Docket : A.23-08-013
Exhibit Number : CA-08
Commissioner : Alice Reynolds
Admin Law Judge : Larsen
Witness : H. Wehrman

PUBLIC ADVOCATES OFFICE
CALIFORNIA PUBLIC UTILITIES COMMISSION

**Testimony on the Koenigstein Ignition
for
Thomas Fire and Debris Flow
Cost-Recovery Application**

The Koenigstein Ignition

Figure 1: Wires down incidents with “unknown” cause⁶⁰

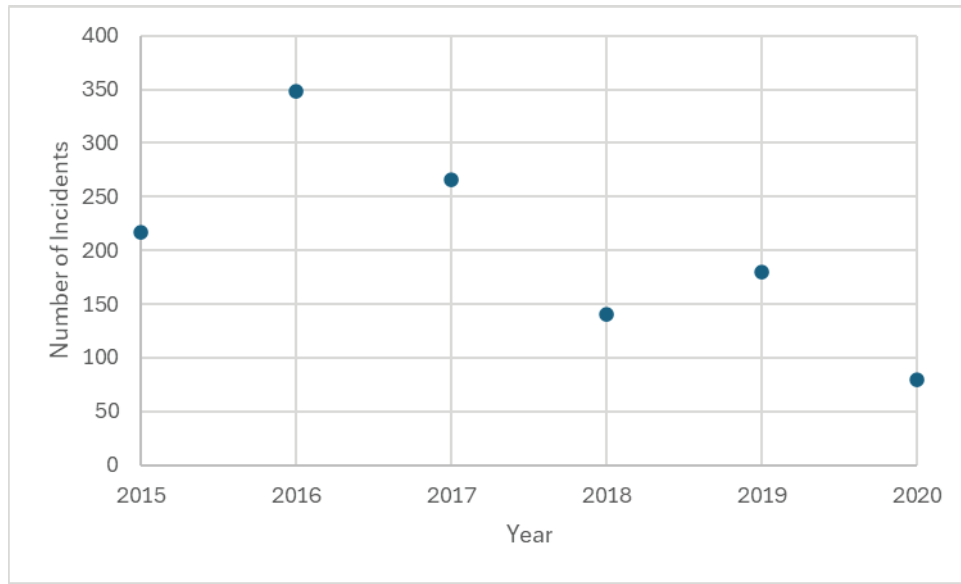
3 Figure 1 shows that there appears to be a general downward trend in wires down
4 incidents with “unknown” cause from 2016 through 2020. However, there is no such
5 trend in the years from 2015 through 2017.

6 In 2015 and 2016, SCE did not record any wire-down incidents related to “wire
7 failure” or “damaged wire.”⁶¹ It is possible that incidents related to wire damage were
8 recorded under another cause field, or as “unknown.” If SCE did not collect data on
9 whether wire-down incidents were related to damaged wire or wire failure prior to 2017,
10 then SCE would have been unable to identify and remediate the root causes of such
11 incidents.
